Technical Information

27/13 ENU 4608

Eliminating Symptoms on Brakes: Replacing Brake Pedal Mount (Brake pedal does not return completely to its end position following actuation/SY2713)

Replacing brake pedal mount - Sports Cars (9x1)

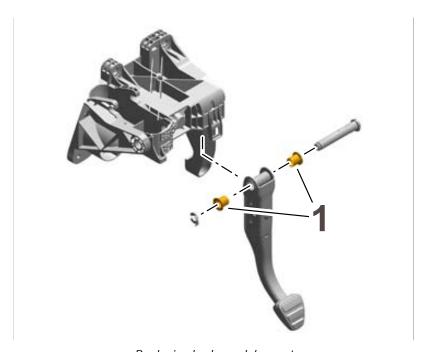
- 1 Remove brake pedal. ⇒ Workshop Manual '460519 Removing and installing brake pedal section on "Removing"
- Replace bushing at the left and right \Rightarrow Replacing brake pedal mount -1-.

Install brake pedal. \Rightarrow Workshop Manual '460519 Removing and installing brake pedal - section on "Installing"

Replacing brake pedal mount - Cayenne (92A)

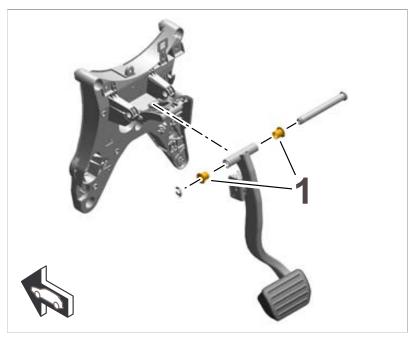
- 4 Remove brake pedal. ⇒ Workshop Manual '460519 Removing and installing brake pedal section on "Removing"
- 5 Replace bush at the left and right \Rightarrow Replacing brake pedal mount -1-.

6 Install brake pedal. ⇒ Workshop Manual '460519 Removing and installing brake pedal - section on "Installing"
